October 28, 2015

SUBJECT: Comments on the Bay Delta Conservation Plan Partially Recirculated Draft Environmental Impact Report/Supplemental Draft Environmental Impact Statement

SUBJECT: Comments on the Bay Delta Conservation Plan and Environmental Impact Report/Environmental Impact Statement

Figure 1. Projected Inflow to Trinity, Shasta, Oroville, and Folsom Reservoirs – NAA, NAA-ELT and NAA-LLT

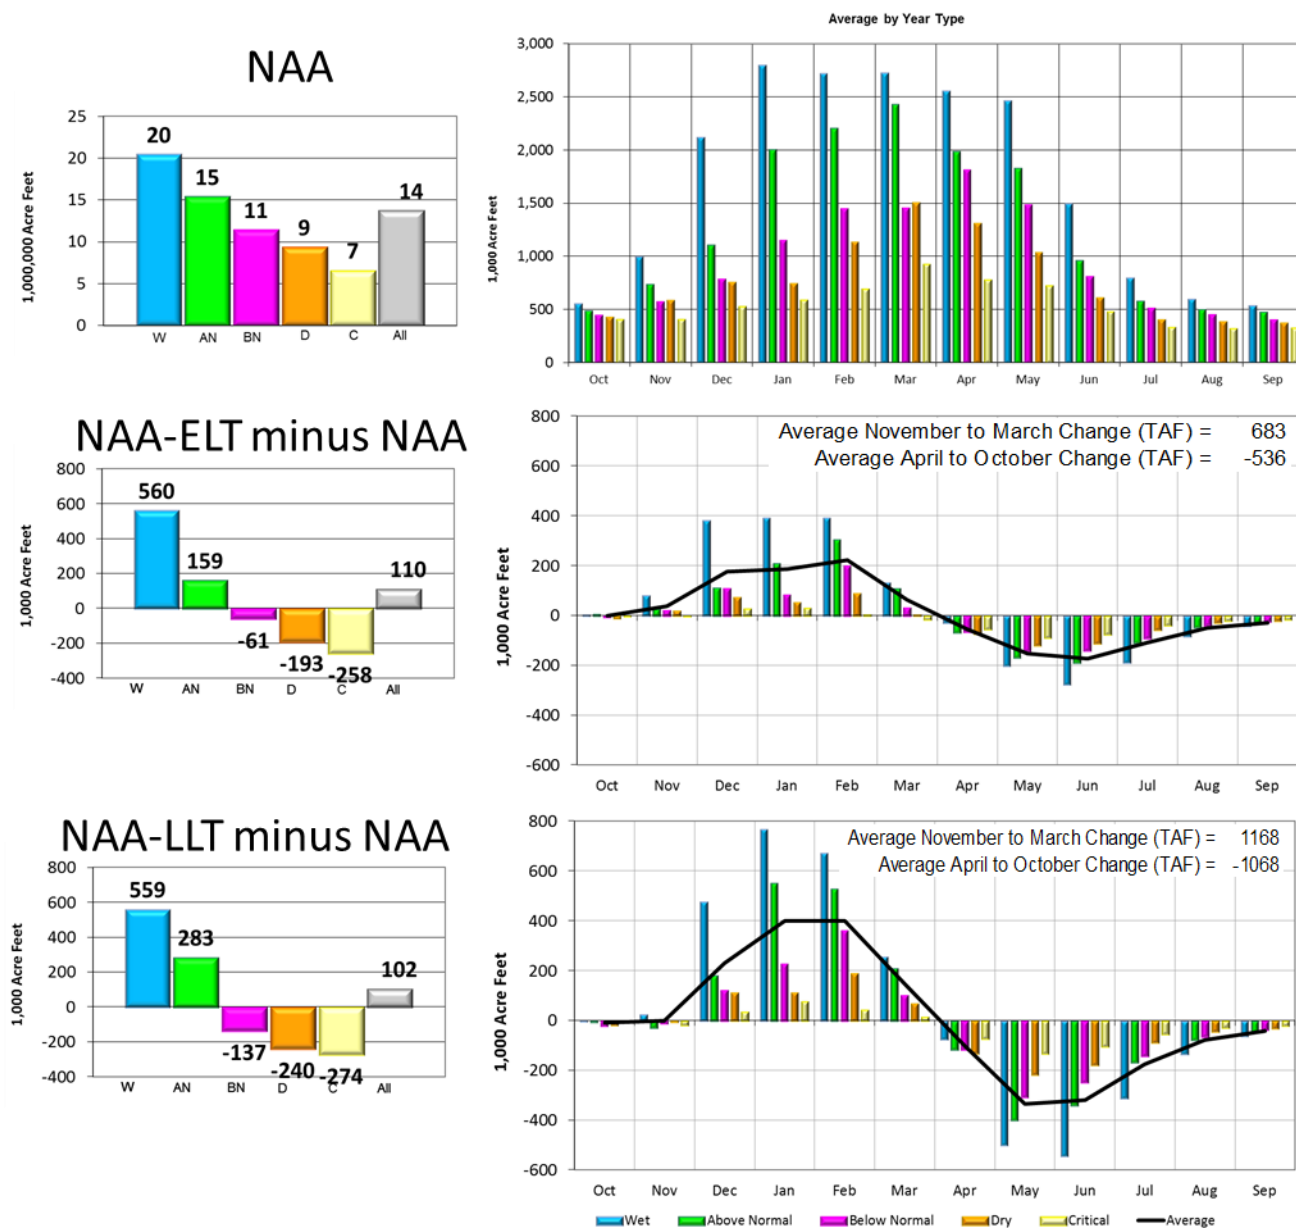
In our opinion, the CalSim II depicted operations that incorporate climate change are not reasonably foreseeable and do not represent a likely future operation of the CVP/SWP. Although an argument is typically made that these study baselines will be used in a comparison analysis with Project Alternatives tiering from these baselines, we believe that the depicted operations do not represent credible CVP/SWP operations and we have no confidence in the results and they are inappropriate as the foundation of a Project Alternative. As such, although the modeling approach may provide a relative comparison between equal foundational operations, we are apprehensive to place much confidence in the computed differences shown between the NAA and Project Alternative Scenarios.

For upstream CVP and SWP reservoirs the assumed shift of inflows due to climate change (Figure 1) along with a continuing need to satisfy exports demands significantly affects carryover storage. The CVP and SWP simply cannot satisfy water demands and regulatory criteria imposed on them in the NAA-ELT and NAA-LLT modeling scenarios.

Figure 2. Projected Shasta Reservoir Carryover Storage, NAA, NAA-ELT and NAA-LLT

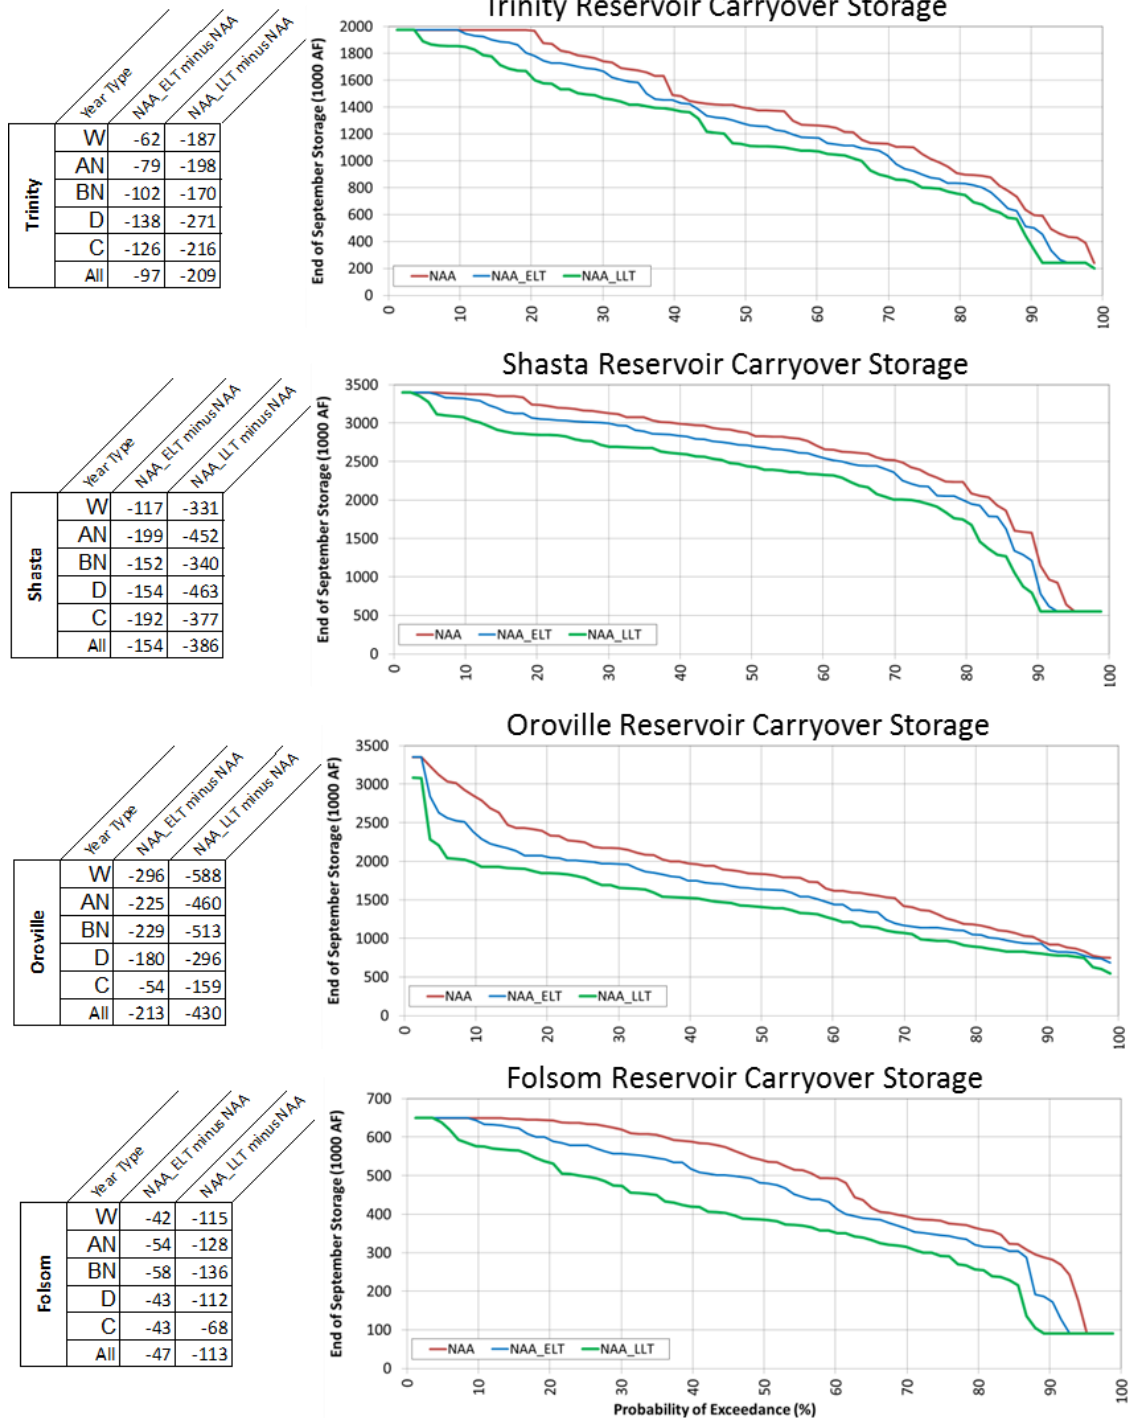
Figure 2 illustrates the typical change in carryover storage as shown for Trinity, Shasta, Oroville, and Folsom Reservoirs. The relatively high frequency (approximately 10% of time) of minimum storage occurring at CVP reservoirs illustrates our questioning of credible operations in the studies.

Figure 3. Projected Inflow to Millerton Lake –NAA, NAA-ELT and NAA-LLT

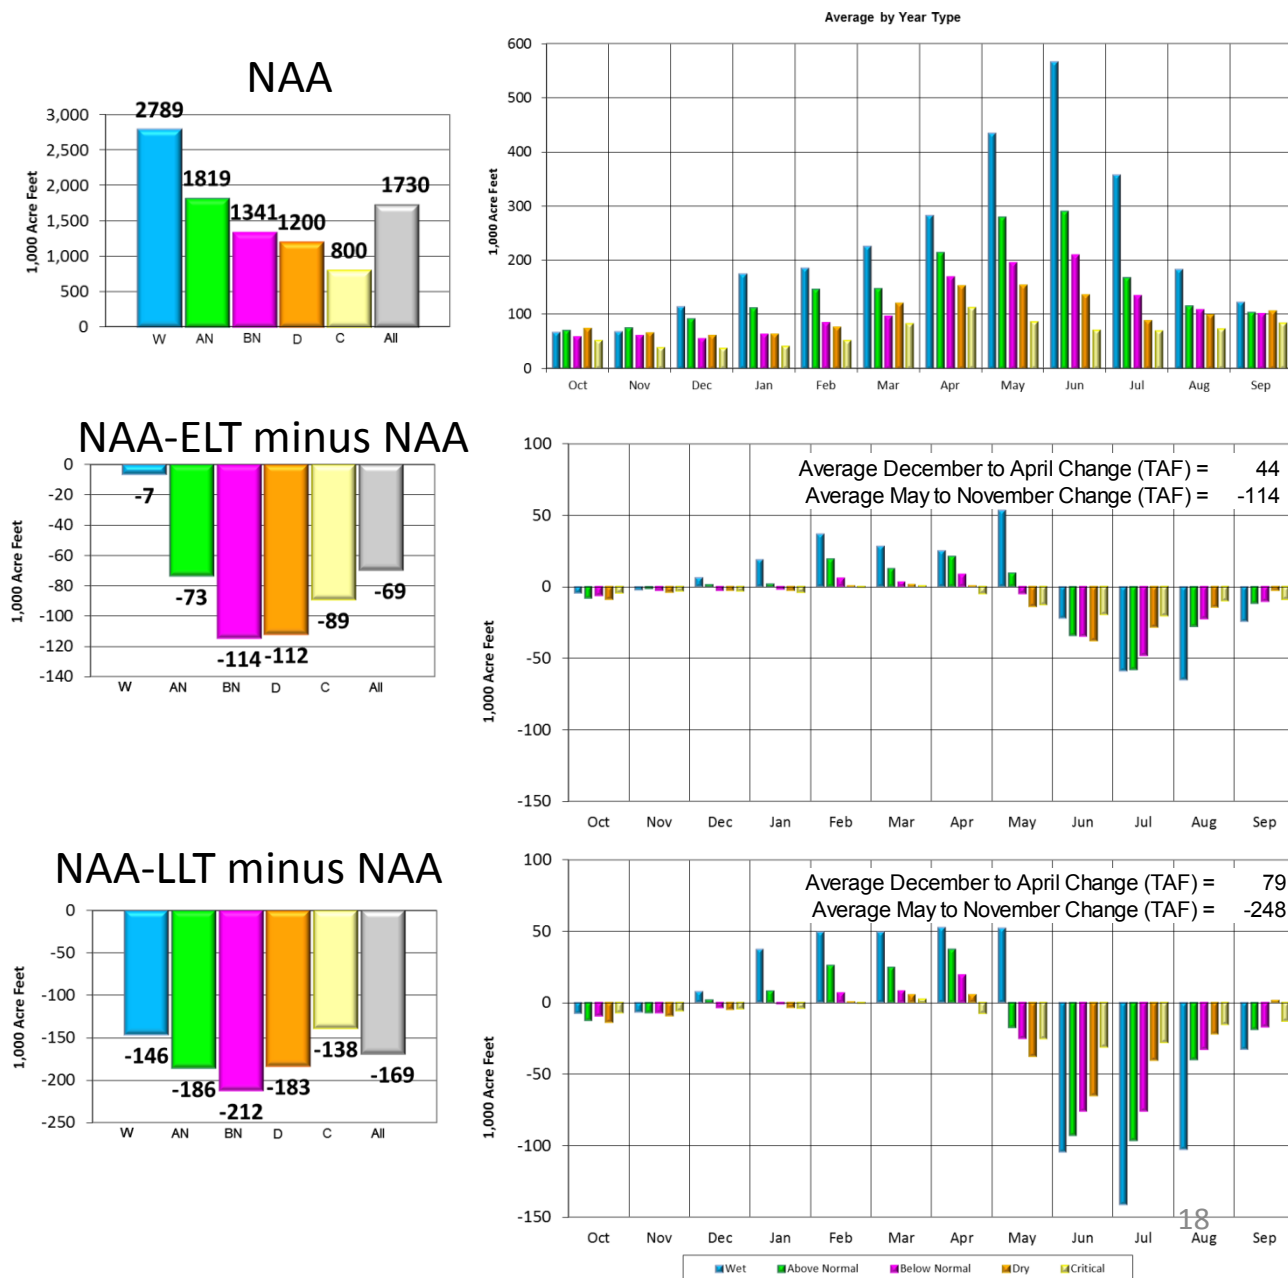
San Joaquin Valley reservoirs are depicted with an overall decrease in annual runoff with some shifting of runoff from spring to winter, but mostly just decreases in spring runoff due to a decline in snowmelt runoff during late spring⁵. Figure 3 illustrates the assumed effects of climate change upon inflow to Millerton Lake.

The hydrology differences imposed in the NAA Scenarios of the Friant Division are described above, and its appropriateness may be subject to additional debate and Alternative assumptions. However, our review found that implementation of Millerton Reservoir inflow as affected by climate change was improperly performed.

Figure 4. Millerton Reservoir Carryover Storage, NAA, NAA-ELT and NAA-LLT Scenarios

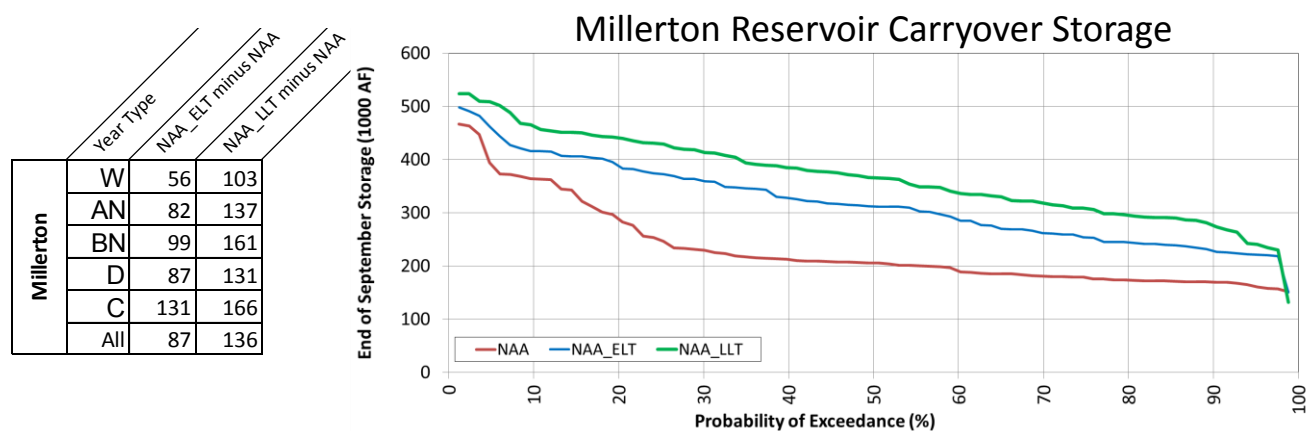
Inflow to Millerton Reservoir in this version of CalSim is input in three separate time series for purposes of depicting the hydrology of potential upper basin reservoirs. Climate change hydrology was inconsistently incorporated at Millerton Reservoir and misapplied to the water supply and flood control operations. The result is an unrealistic operation for river releases and canal diversions. Figure 3 illustrates the projected ELT and LLT changes in Millerton Reservoir inflow incorporated in these studies. On face value of the input data, regardless of Friant Dam river release assumptions the effect of climate change at Millerton Lake will affect water deliveries.

Evidence of the inconsistent inflow problem is shown in the result for the comparison of carryover storage of Millerton Reservoir under the NAA, NAA-ELT, and NAA-LLT Scenarios (Figure 4). Carryover storage is higher in the ELT and LLT Scenarios due to climate change effects to inflow incorporated in reservoir operations but not in the computation of water supply deliveries. Thus, water deliveries are suppressed and the reservoir ends the year with greater storage.

Figure 12. Temperature Exceedance Sacramento River at Bend Bridge Existing, No Action Alternative, ELT

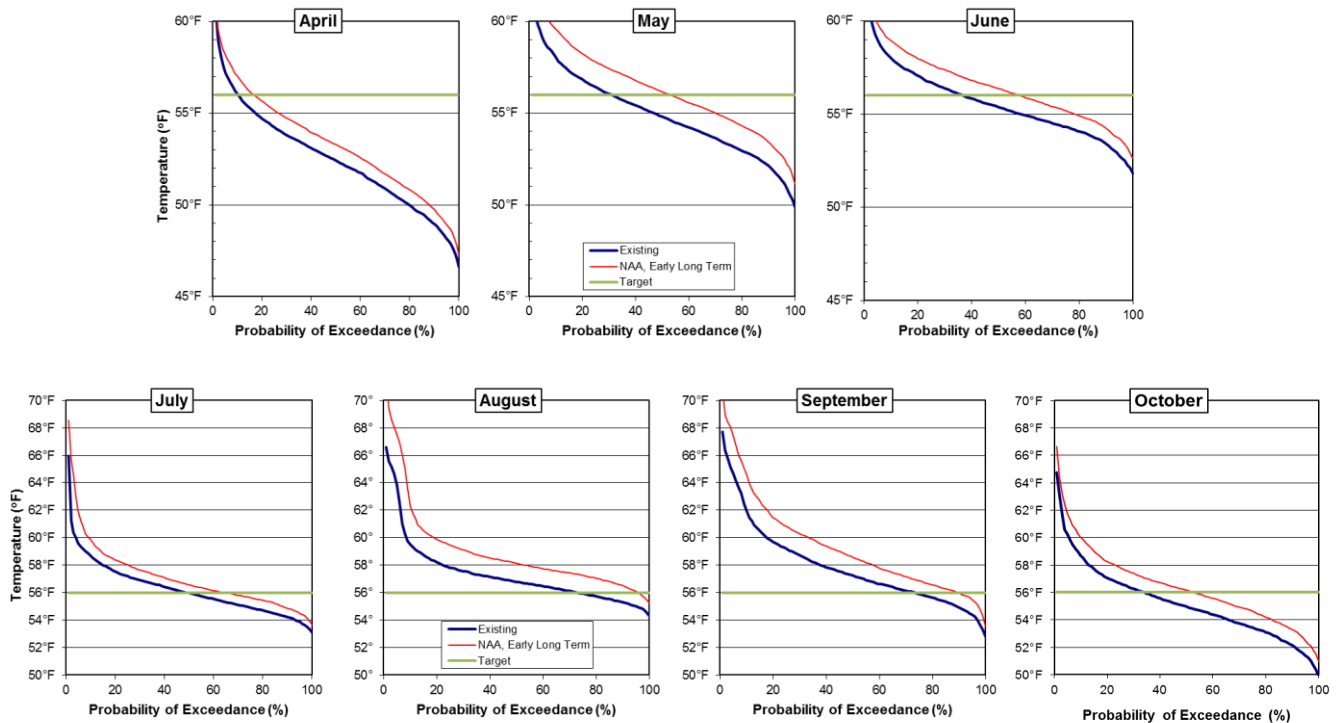
The increase in equilibrium temperatures combined with decreases in storage would lead to water temperature conditions that would likely not achieve the assumed objectives. Figure 12 and Figure 13 illustrate an increase in the probability that a water temperature target of 56°F would be exceeded at Bend Bridge under both the NAA-ELT and NAA-LLT Scenarios. The probability of exceedance increases approximately 5% to 20% depending on the month for the NAA-ELT Scenario and approximately 10% to 40% for the NAA-LLT Scenario.

Figure 19. NDD, Bypass Requirement, Bypass Flow, and Excess Sacramento R. flow for Alt 4-ELT

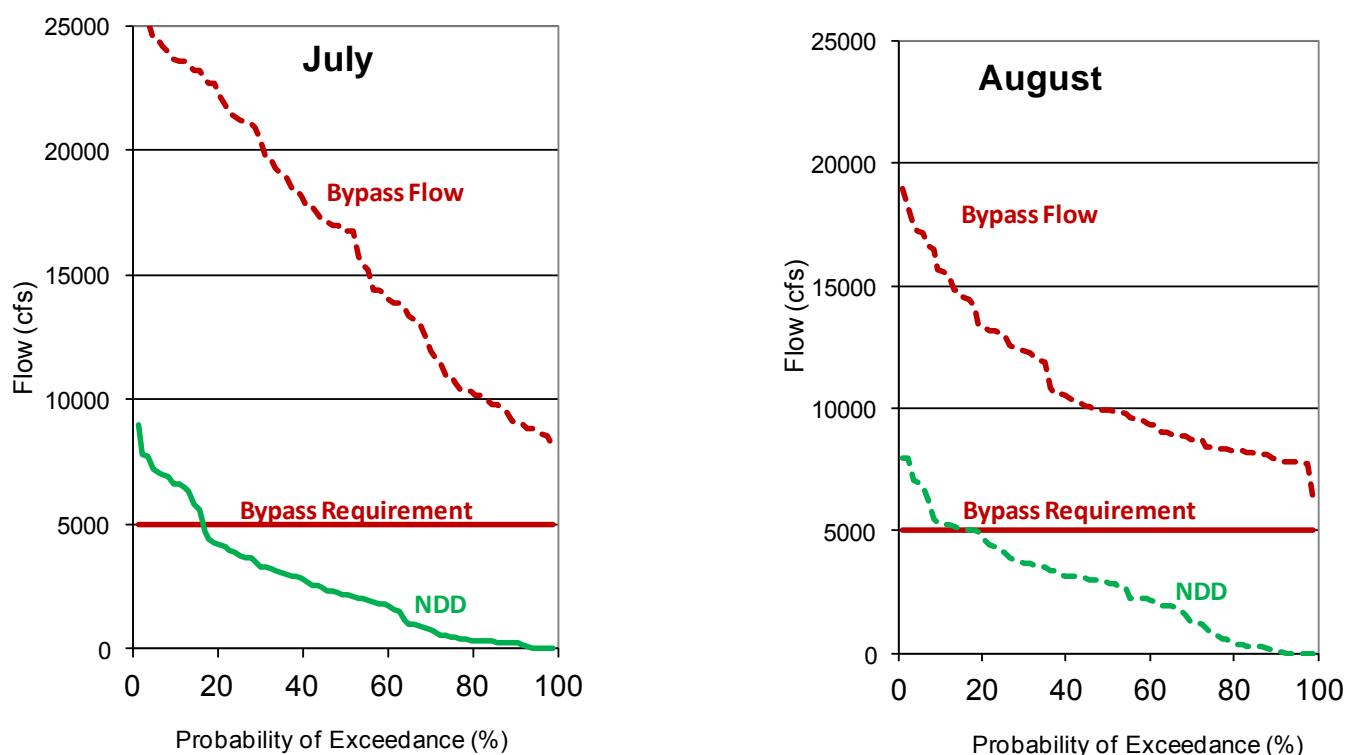
Sacramento River flow below the North Delta Diversion (NDD) must be maintained above the specified bypass flow requirement, therefore the NDD rates are limited to the Sacramento River flow above the bypass requirement. Due to an error in CalSim II that specifies an unintended additional bypass requirement, modeling performed for the BDCP EIRS often bypasses more Sacramento River flow than is specified in the BDCP project description. This error has been fixed in the most recent public releases of CalSim II, but BDCP modeling has not been updated to reflect these fixes. Figure 19 contains exceedance probability plots showing the Sacramento River required bypass, Sacramento River bypass flow, NDD, and excess Sacramento River flow to the Delta as modeling for BDCP. As can be seen in Figure 19, the bypass flow is always above the bypass requirement in July and August. The BDCP version of CalSim sets a requirement for Sacramento River inflow to the Delta needed to satisfy all Delta flow, quality, and export requirements, this requirement should be removed when modeling the NDD.

Figure 22. Alt 4-ELT North Delta Diversion Versus South Delta Diversion for July, August, and September

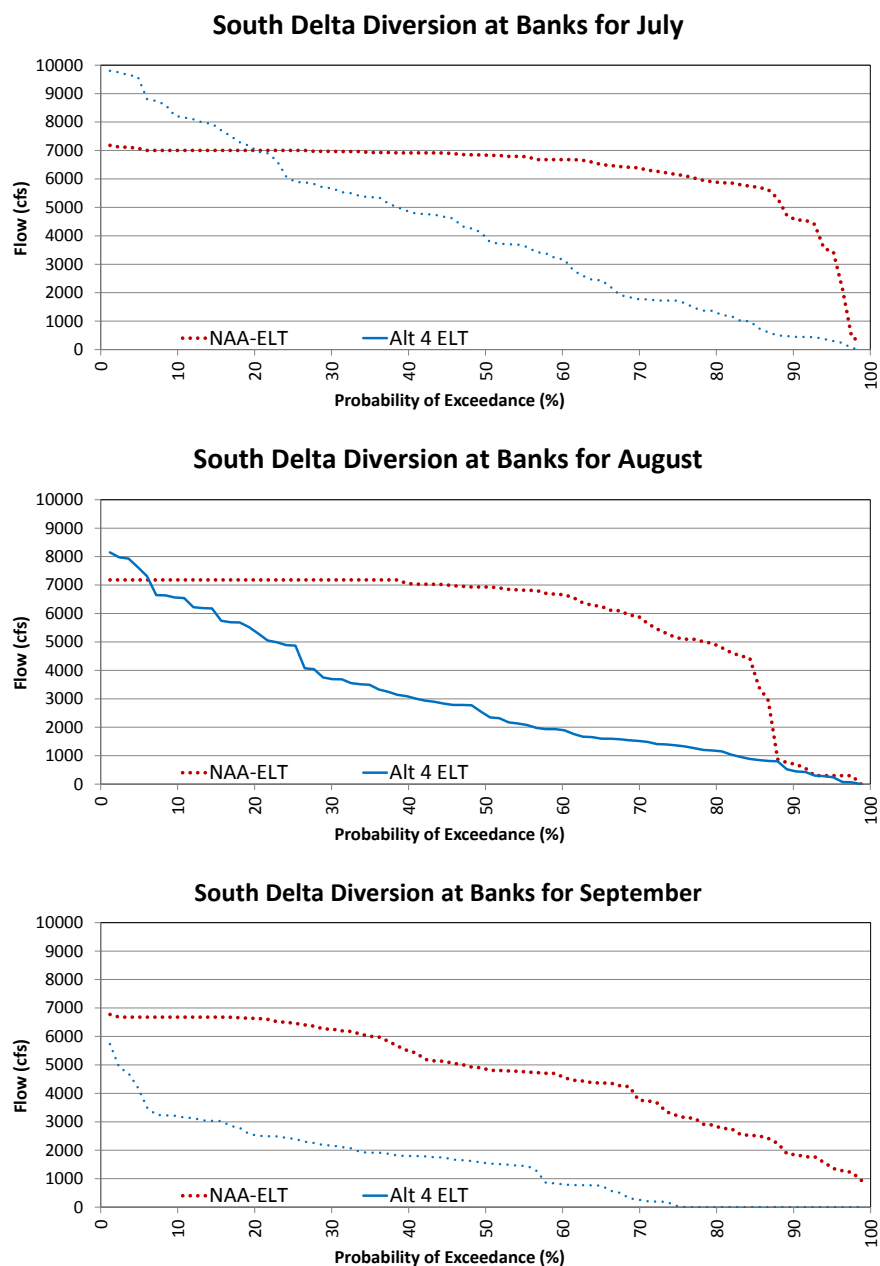
Figure 22 contains figures for July, August, and September for Alt 4-ELT that plot NDD against SDD. In the months of July to September SDD are occasionally very high, exceeding 14,000 cfs in July, with minimal NDD. This occurs due to outdated model code that imposes an instream flow requirement in Sacramento River flow below Hood in excess of the bypass criteria prescribed in the BDCP. There are numerous occurrences when bypass flows prescribed in the BDCP are exceeded and SDD are higher than expected. On the other hand, there are also many times when NDD are above minimum pumping levels and SDD are below the BDCP prescribed 3,000 cfs threshold indicated by the green line in Figure 22. For unknown reasons, the model code requiring SDD to be greater than 3,000 cfs before NDDs occur from July through September is deactivated in the BDCP modeling of this Alternative.

Figure 24. Delta Outflow Change (Alt 4-ELT minus NAA-ELT)

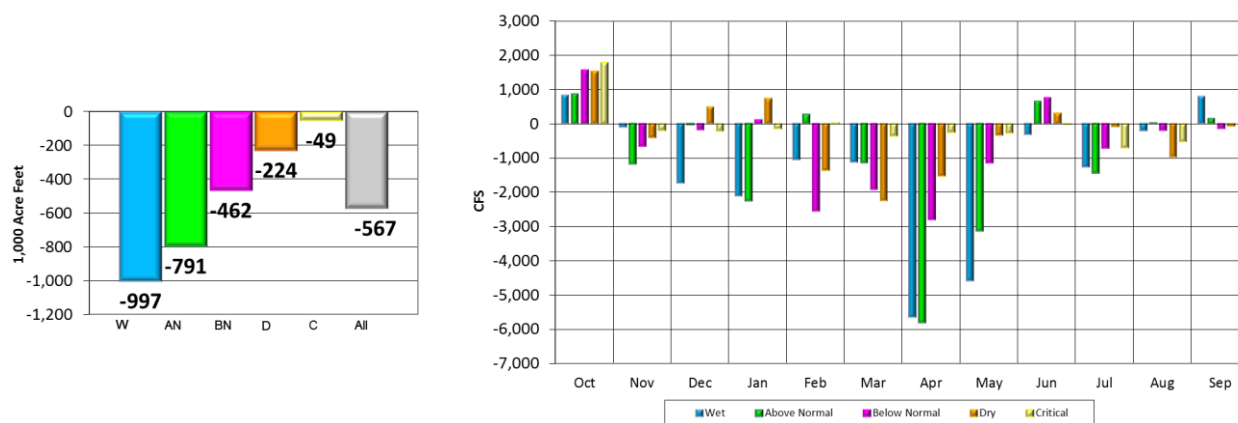
Figure 24 illustrates a comparison of Delta outflow between the NAA-ELT and Alt 4-ELT. Decreases in Delta outflow are the result of the CVP and SWP ability to increase Delta exports in Alt 4-ELT. The apparent increase in Delta outflow in October is partially due to additional export restrictions though Old and Middle River flow requirements. However, the increase in October Delta outflow is also due to an unrealistic operation of the Delta Cross Channel. The additional export restrictions cause the flow standards imposed at Rio Vista to be the controlling point in CVP and SWP operations; the water quality standards are all being met and do not require

flows above the amount needed to satisfy the Rio Vista standard. Meeting the Rio Vista flow standards without closing the Delta Cross Channel gate results in releasing more water from upstream reservoirs than would otherwise be necessary. This occurs because a certain amount of the water released to meet the Rio Vista flow standards would flow into the Central Delta at location of the Delta Cross Channel gate. This water would not make it to Rio Vista and therefore would not be counted towards meeting the Rio Vista flow standards. However, due to the BDCP model's assumed restrictions on exports at this time, this water could not be pumped from the South Delta facilities and thus ends up as "extra" Delta outflow. By closing the Delta Cross Channel gate, the operators would assure that all of the water released to meet the Rio Vista flow standards would be counted towards those standards. The BDCP model's assumptions that the Delta Cross Channel gate would not be closed are not practical or a sensible operation as the operators confirmed they would close the gate during these conditions to avoid the unnecessary loss of water supplies (as was done in October and November 2013). The assumption in the BDCP model to maintain the gate in the open position causes it to overstate the amount of Delta outflow.
